## SERVICE LETTER 213

### FIRE BOSS FINLET ATTACH BOLTS REINSTALL

<b>Aircraft Makes/Model(s):</b>	<b>Float Model(s):</b>	<b>Compliance:</b> Mandatory	<b>By:</b> MAS
Air Tractor AT-802 & AT-802A	10000A	<b>Part Number:</b> 1011544	<b>Approved:</b> DRH
		<b>Date:</b> 3/13/2026	<b>Revision:</b> A.1

Figure 1

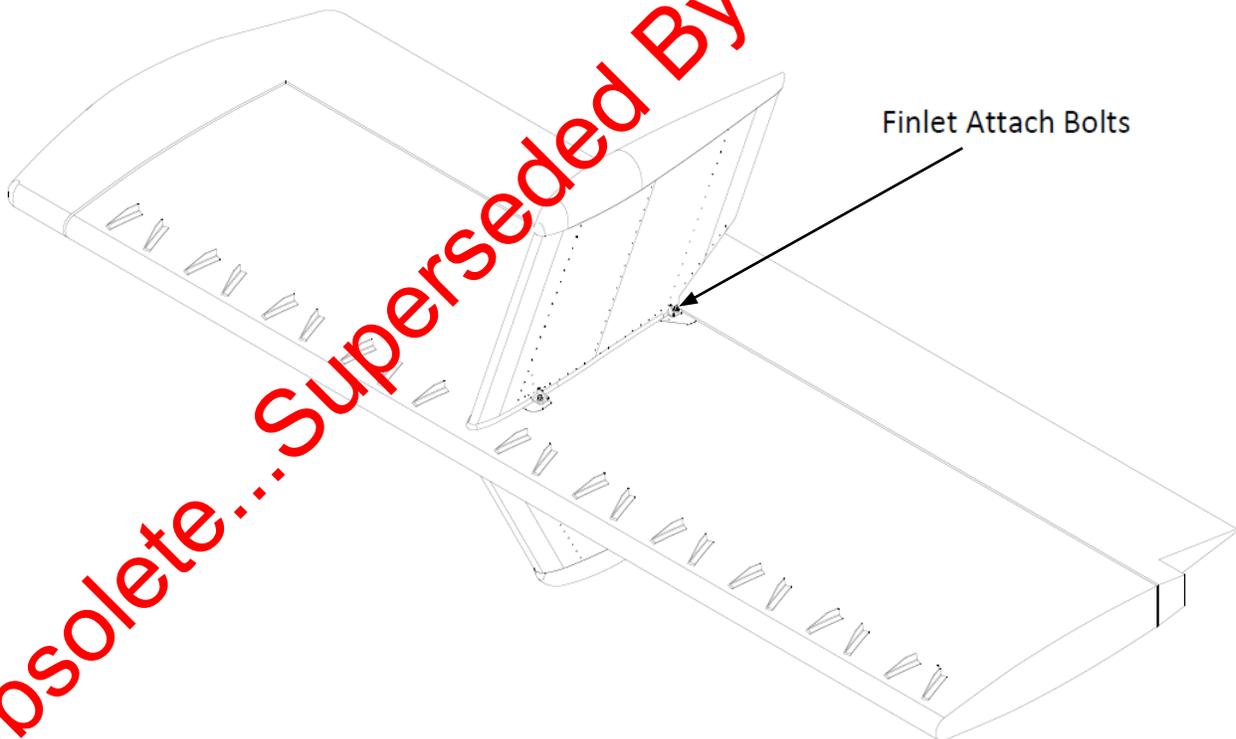
It is possible that the locking feature of the Fire Boss finlet bolt attach nutplates can become degraded. This service letter adds medium strength Loctite 242 (or equivalent thread locker) to the bolt installation as a secondary locking mechanism.

Reference Figure 1 below.

1. For all 4 finlets (top and bottom, LH/RH side): Remove and reinstall the ¼" attach bolts into the nutplates of the horizontal tail.
  - a. Apply Loctite 242 or equivalent thread locker (medium strength) to the bolt when reinstalling.
  - b. Torque the attach bolts in a range from 50 in-lbs. to 70 in-lbs.
  - c. Apply Torque Stripe.

**WARNING:** In order to maintain the locking feature of the nutplate, DO NOT RUN A TAP INTO THE NUTPLATE.
